ADNOC GAS
LONG TERM - EXECUTE STAGE
PROJECT 5.0 (P5)
EPCm FOR HABSHAN DBN
COMPANY PROJECT No. 30201-50150-LT-HE
WORK ORDER NO. 3000076501

Comments Resolution Sheet (CRS) - EPCm

COMPANY Trans. No.	**ADNOCGP-WTRAN-023421**	**Received Date:**	**3-Feb-26**
COMPANY Doc. No.:	**DC-30201_50150_LT_HE-H4-278-17-23-004**	**Revision:**	**B**
Document Title:	**FOUNDATION GA & DETAILS OMS-201**	**Status Code:**	**Code 2**
ADNOC PM:	**Dr Azharuddin Mohammed**	**EPCm. CONTRACTOR PM:**	**Sriram PS**
ADNOC Reviewer:	**Mr Abhishek Srivastava, Mr Sreekanth Nuthanapati, Mr Vinodhkumar Ranganathan**	**EPCm. CONTRACTOR Originator:**	**Ankita Chatterjee**

FOUNDATION AND COLUMN LAYOUT

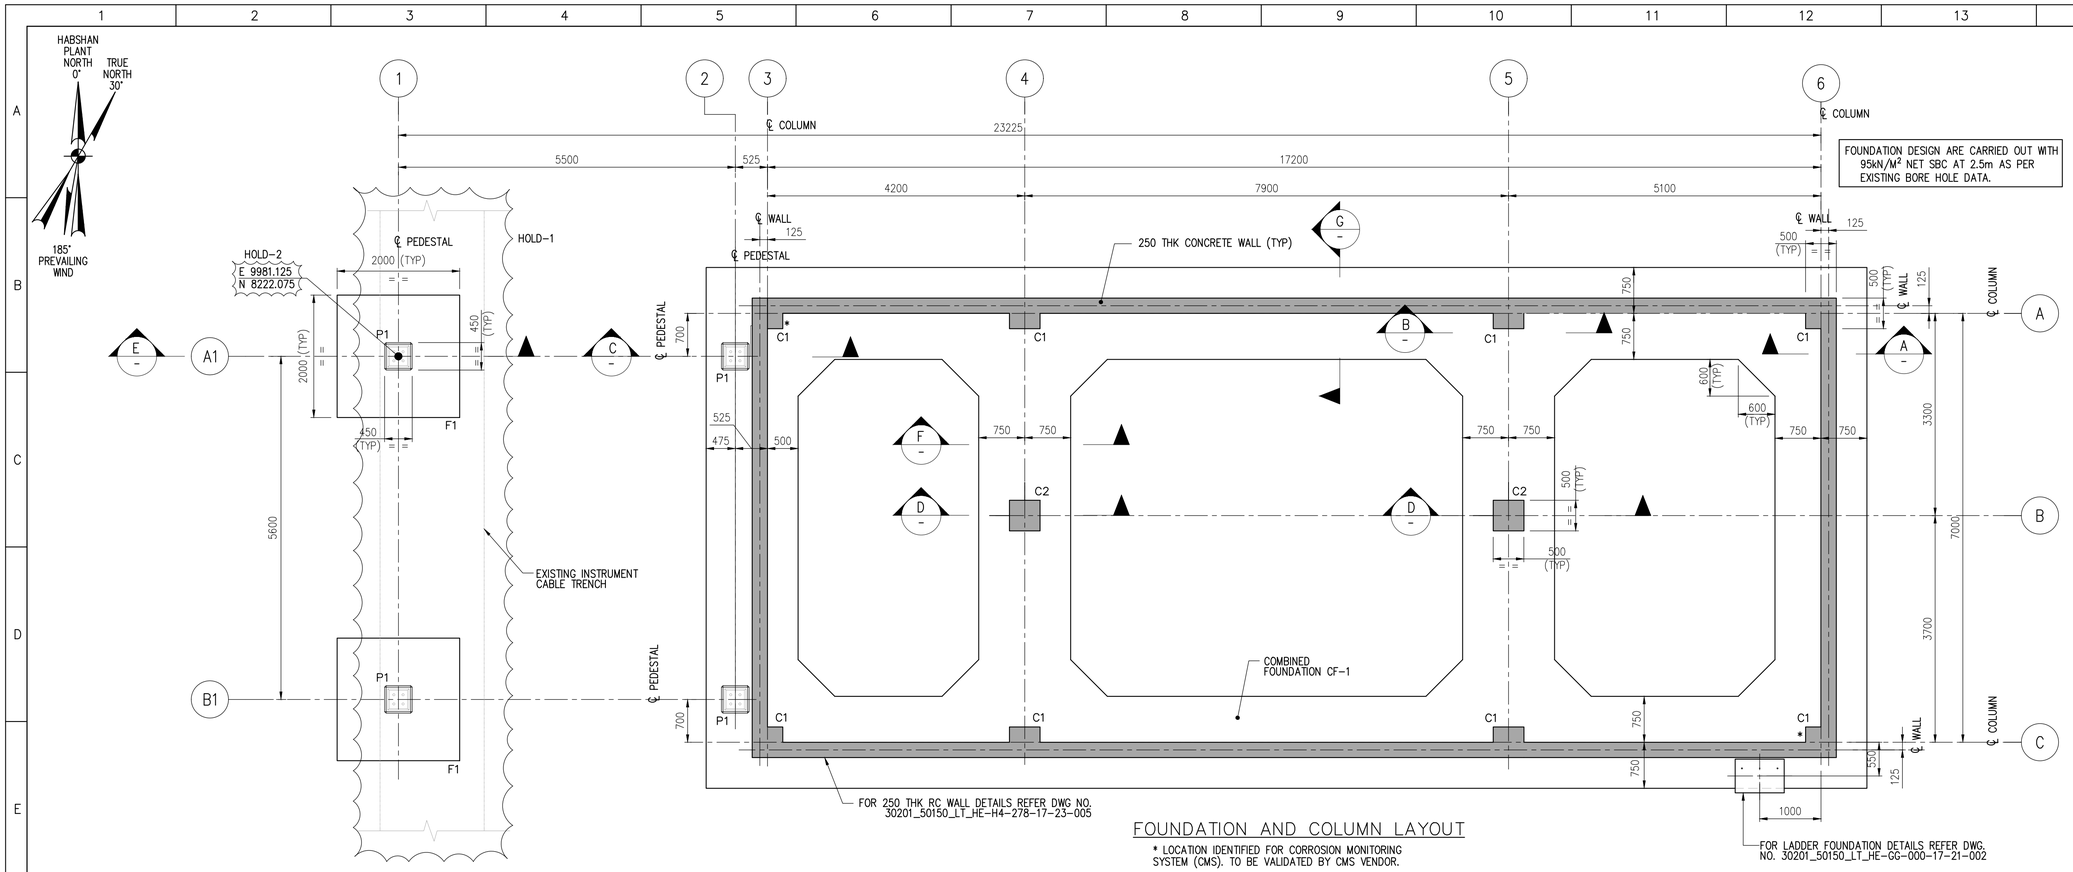
2		2	Ensure that the location of the building is approved by CPY HSE	Mr Vinodhkumar Ranganathan	CPY HSE to approve the location of building.	OPEN		CPY HSE YET TO APPROVE BUILDING LOCATION		
3		2	Update to show all the UG items	Mr Vinodhkumar Ranganathan	Noted and all UG items are updated	OPEN	Comment not incorporated.Update	noted & incorporated		
4		2	When wall extended from foundation, Centre line of wall and foundation should have been aligned. Justify the proposal.	Mr Vinodhkumar Ranganathan	outer face of wall and column is aligned as per architectural requirement.		Noted			
5		2	correct the pointer	Mr Vinodhkumar Ranganathan	Noted and Updated		Noted			
6		2	Mention where to refer the Grade slab details	Mr Vinodhkumar Ranganathan	Noted and grade slab reference details are updated		Noted			
7		2	RCC wall? check the requirement and update as required	Mr Vinodhkumar Ranganathan	RCC WALL REMOVED AS PER LATEST ARCHITECTURAL DRAWING.	OPEN	CRS reply not aligned with drawing. Comment not complied. Update	drawing updated.

8		2	Update to show all the required cut-outs/sleeves for envisaged UG items.	Mr Vinodhkumar Ranganathan	Noted . As both buildings are blast resistant and have identical geometry hence one common calculation is prepared.	OPEN	Comment not incorporated.Update	Cutouts are currently kept under hold.		
9		2	Update per feedback provided on the design calculations related to the requirement of two separate reports and other comments	Mr Sreekanth Nuthanapati	Noted and updated as per the calculations		Noted			
10		2	Update to show the embankment extent	Mr Vinodhkumar Ranganathan	UG combosite layout is not yet updated.	OPEN	Update to show existing embankment, and include reference drawing numbers for any modification of the same	embankment is far from building , not coming in drawing as per scaled distance.		
11		2	Architectural drawings shall be in code 3 before the IFC of the foundation drawings.	Mr Vinodhkumar Ranganathan	Noted.	OPEN	Open.Provide the response	Arch drawing under progress,shall be issued later

12		2	Any update required based on the UG detection survey and slit trenching shall be carried out.	Mr Vinodhkumar Ranganathan	Noted.	OPEN	Open.Provide the response	Slit trench is proposed. but activity not performed.		
13		2	EPCM to reverify with the execute stage Geotechnical report before the Final submission.	Mr Vinodhkumar Ranganathan	Noted.	OPEN	Open.Provide the response	verified with nearest Bore hole data in Execute stage geotech report.		
14		2	Any update required based on the 3D model review comments shall be carried out.	Mr Vinodhkumar Ranganathan	Noted.	OPEN	Open.Provide the response	model review in progress,		
15		2	Any update required based on the comments in structural and Foundation calculation report shall be carried out.	Mr Vinodhkumar Ranganathan	Noted and incorporated.		Noted			
16		2	Ensure 3D model and drawings align each other.	Mr Vinodhkumar Ranganathan	Noted.		Noted

17		2	Update to add the MTO table	Mr Vinodhkumar Ranganathan	Noted and updated the MTO table		Noted			
18		2	Update to add the GWT in terms of level.	Mr Vinodhkumar Ranganathan	Depth of water table is mentioned in calculation report, based on that suitable concrete protection type is mentioned in drawing sections.	OPEN	Update to mention EL of GWT in drawing	GWT EL mentioned as per nearest bore hole data from execute stage geotechnical report.		
19		2	Align with Materials and corrosion for the criticality. Also, align with CP vendor for the required details and execute during the foundation casting. Ensure to align the timeline with CP vendor	Mr Vinodhkumar Ranganathan	Noted.	OPEN		CP Vendor not finalised yet		
20		2	Define type of protection based on GWL considering seasonal variation	Mr Sreekanth Nuthanapati	Protection type is mentioned in section.	CLOSED	Noted			
21		2	Add a table with grade of concrete, rebar and clear cover for foundation, column, beam	Mr Vinodhkumar Ranganathan	Noted and incorporated.		Noted

4	Recommend to consider T10 @ 100 inside the footing for the buildings	Mr Vinodhkumar Ranganathan	Noted & Incorporated					
		2	Check location of maintenance shed, not matching with 3d model and plot plan. Update to align 3d model and drawings.	Mr Mandar Nadgouda	Location of maintenance shed is matching as per Arch drawing. Plot plan and 3D model to be updated yet.					
		2	check and update to correct wall type	Mr Mandar Nadgouda	updated					
		2	Update to move text.	Mr Mandar Nadgouda	updated					
		2	Not matching with Arch dwgs. Ensure to align Arch dwgs and Conc foundation dwgs. Typical comment.	Mr Mandar Nadgouda	Noted & Incorporated					
		2	Add section to show details at junction of wall and foundation.	Mr Mandar Nadgouda	Noted & Incorporated					
		2	Check TOC and update to correct.	Mr Mandar Nadgouda	Noted & Incorporated					
		2	Update to mention above ground concrete protection. Typ. comment.	Mr Mandar Nadgouda	Noted & Incorporated

2	Update to indicate UG trenches and show cutouts in walls for cable entry. Typical comment.	Mr Mandar Nadgouda	Noted & Incorporated					
		2	TO be updated as per Toilet slab TOC.	Mr Mandar Nadgouda	Noted & Incorporated

FOUNDATION REINFORCEMENT PLAN FOR CF-1 AND F1

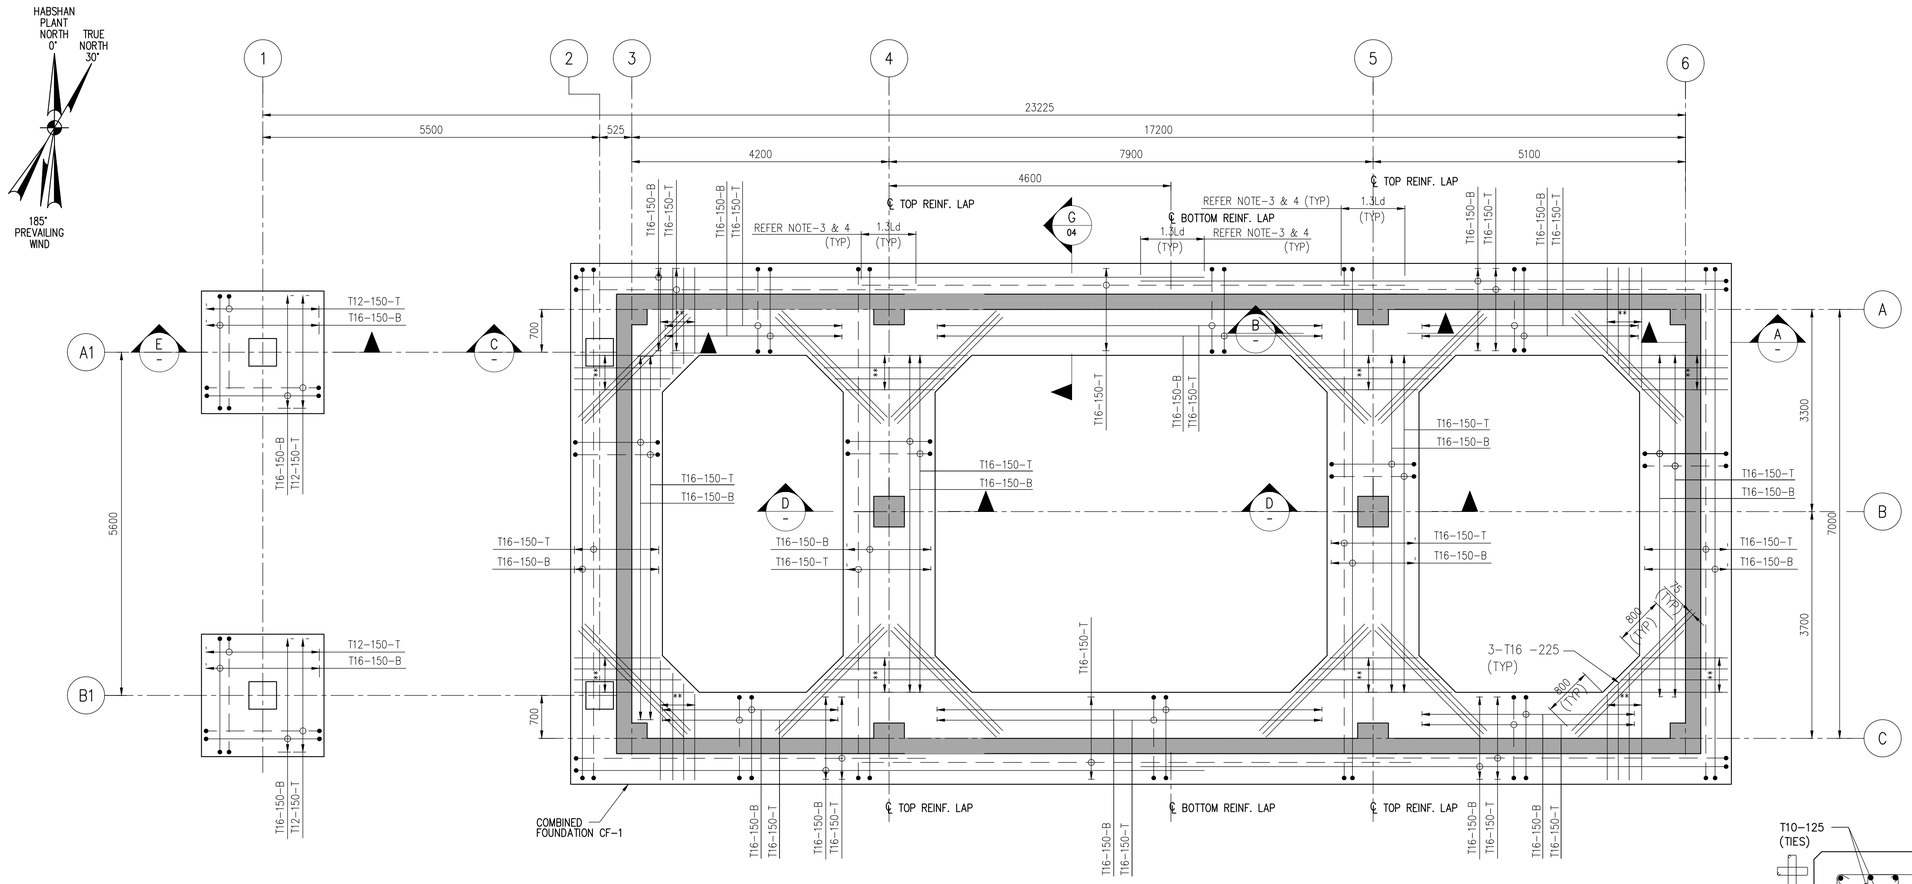
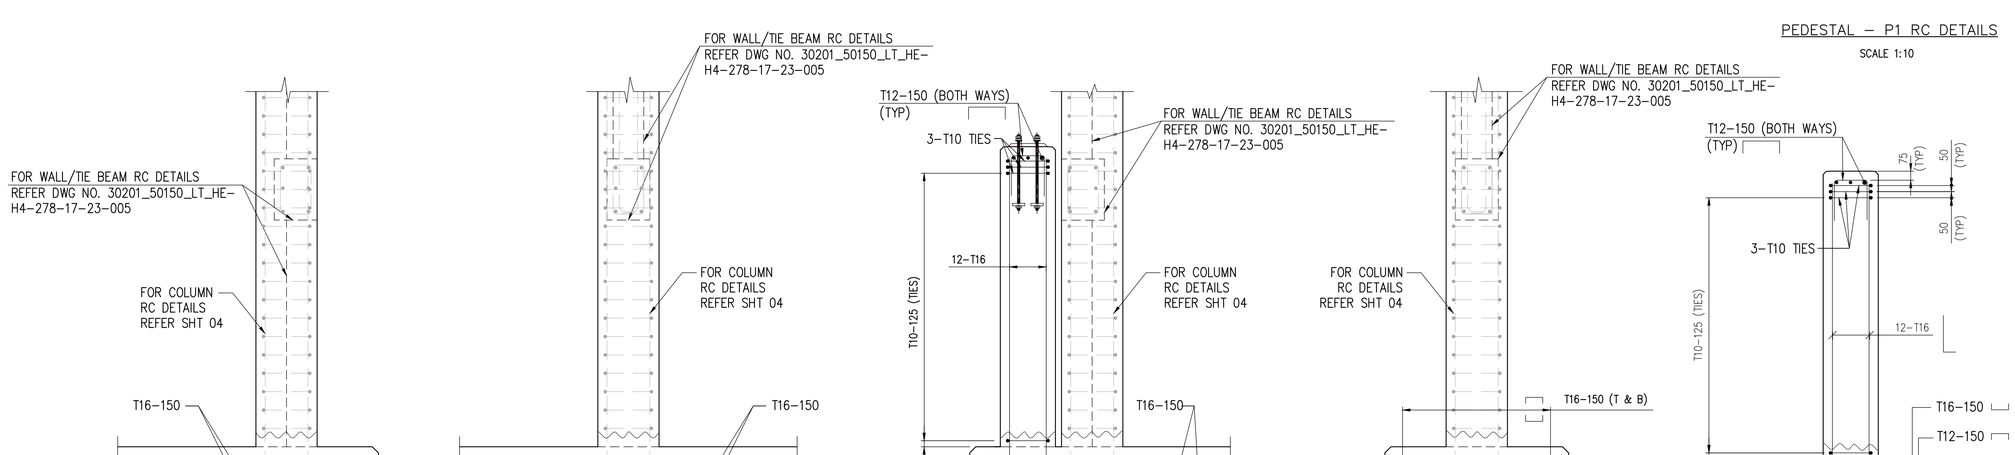
22		3	check the detailing code and update the shape as required. seems to be not okay. Typical comment	Mr Vinodhkumar Ranganathan	Noted and incorporated.		Noted			
23		3	Extend the pedestal rebar	Mr Vinodhkumar Ranganathan	Noted and pedestal rebar extended.		Noted			
24		3	Update to shown the lapping staggering distance	Mr Vinodhkumar Ranganathan	Noted and incorporated.		Noted			
25		4	Update the detailing considering RC wall and no grade beam	Mr Sreekanth Nuthanapati	Detail with grade beam retained as per standard drawing.		Noted			
26		4	For blast resistant, detailing shall be as per SMRF. Check and update	Mr Vinodhkumar Ranganathan	Noted and incorporated.		Noted			
27		4	Seems to be not okay. Reverify and update as required	Mr Vinodhkumar Ranganathan	Rebar size optimised.		Noted			
					REV B					
		3	Please refer the E08 type standard earthing installation from drawing 30201_50150_LT_HE-GG-000-16-21-001 for REINFORCEMENT CONCRETE STRUCTURE	Mr Kiranbhai Kuntmal	Earthing standard is added to reference drawing list.

COLUMN C1/C2 REINFORCEMENT DETAILS

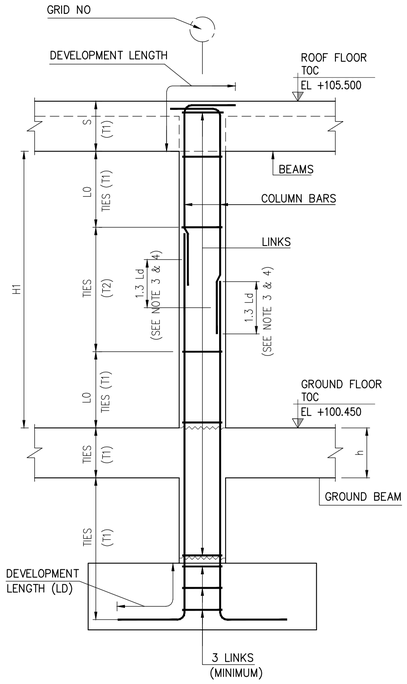
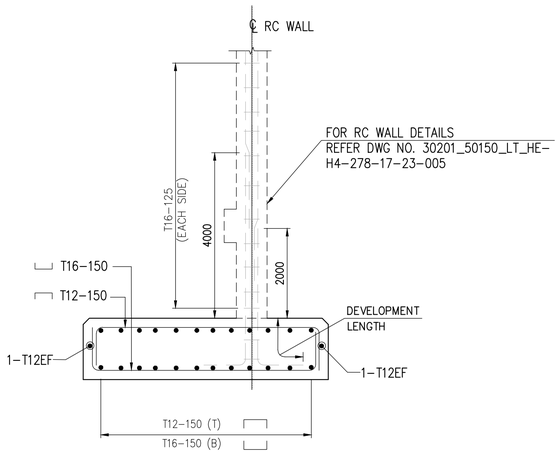
4	Update to show separate description for bars with varying length in this portion. Typ. comment	Mr Mandar Nadgouda	Noted & Incorporated					
		4	Update to show dimensions from edge	Mr Mandar Nadgouda	Noted & Incorporated					
		4	Not matching with calculation report. Update to align drawings and calculation report.	Mr Mandar Nadgouda	Drawing and Calculation Aligned					
		4	Check for side bars and update. Typ. comment	Mr Mandar Nadgouda	Side bars added for 600 thick foundation					
		4	Add section to show reinf details at junction of wall and foundation.	Mr Mandar Nadgouda	Noted & Incorporated					
		4	Update to add reinf details at junction of wall and column. (corner detail). Typ. Comment	Mr Mandar Nadgouda	Noted & Incorporated					
		4	3 ties minimum within footing depth. Update. Typ. comment	Mr Mandar Nadgouda	Noted & Incorporated					
		4	Show location of rebar splice with distance for staggering.	Mr Mandar Nadgouda	Noted & Incorporated
